# UNITED STATES PATENT AND TRADEMARK OFFICE

10/524,599

# Office Action Summary

FIG. 1

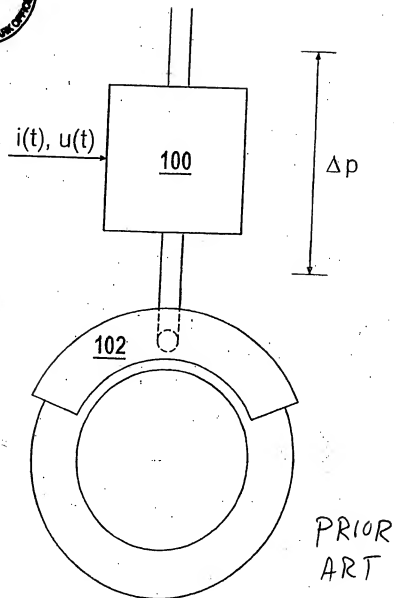
approved  
xw  
7/5/07
